City of Dublin Planning and Zoning Commission

Planning Report

Coffman Park PUD – Skate Park
6565 Commerce Parkway

14-117AFDP
Amended Final Development Plan
Coffman Park PUD - Skate Park
6565 Commerce Parkway

Coffman Park Site

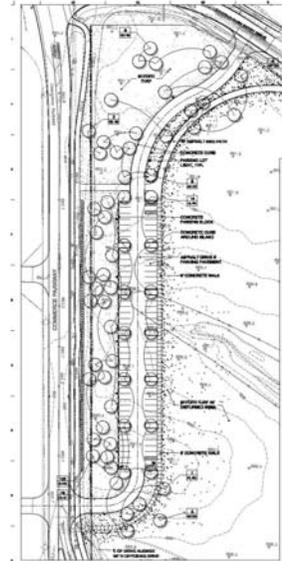
- 80 parking spaces
- 9 parking lot lights, 20 feet high
- 10-foot asphalt bike path located at the northern portion of the site with access off of the existing paths along Post Road and Commerce Parkway
- 6-foot concrete walks that connect to the proposed bike path as well as the existing sidewalk along Commerce Parkway
- Landscaping to provide a buffer between the parking and Commerce Parkway

Justice Center Site

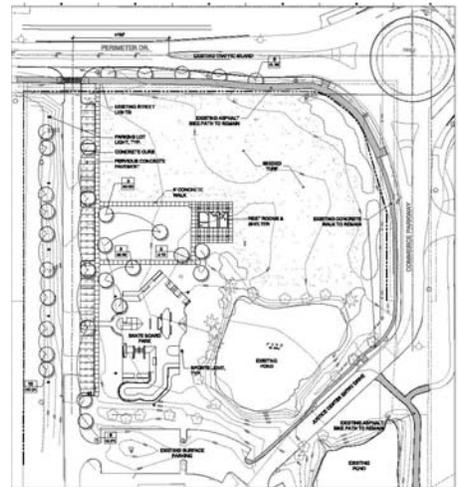
- Restroom/shelter
- Skateboard park and 5 sport lights, 50 feet high
- 35 pervious concrete parking spaces located on the east side of the access drive connecting to existing parking areas
- 5 parking lot lights, 20 feet high
- 6-foot concrete walks connecting the parking, restroom/shelter and skateboard park
- Landscaping
- Grading for future modifications

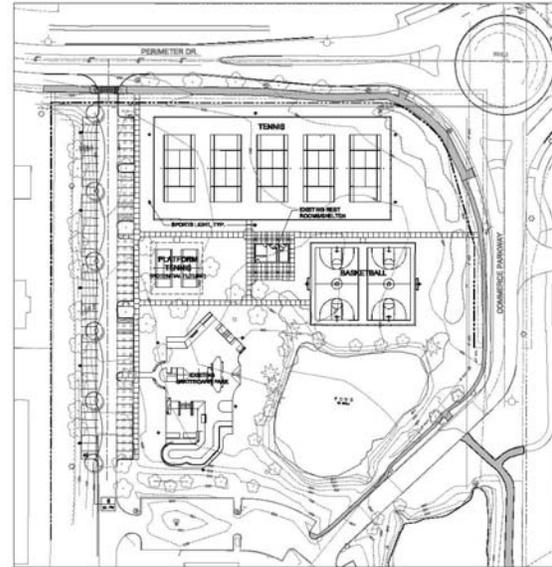
- Phase II-B: Justice Center Site
- 5 tennis courts with 10-foot sports barrier and 6 sport lights, 50 feet high
 - Potential for 2 platform tennis courts
 - 2 basketball courts with 8-foot sports barrier and two sport court lights, 50 feet high
 - 40 additional parking spaces on the west side of the access drive
 - 6-foot concrete walks connecting Commerce Parkway, basketball and tennis courts to the paths proposed in phase II-A
 - Landscaping
 - Demolition of the existing skate park, basketball and tennis courts
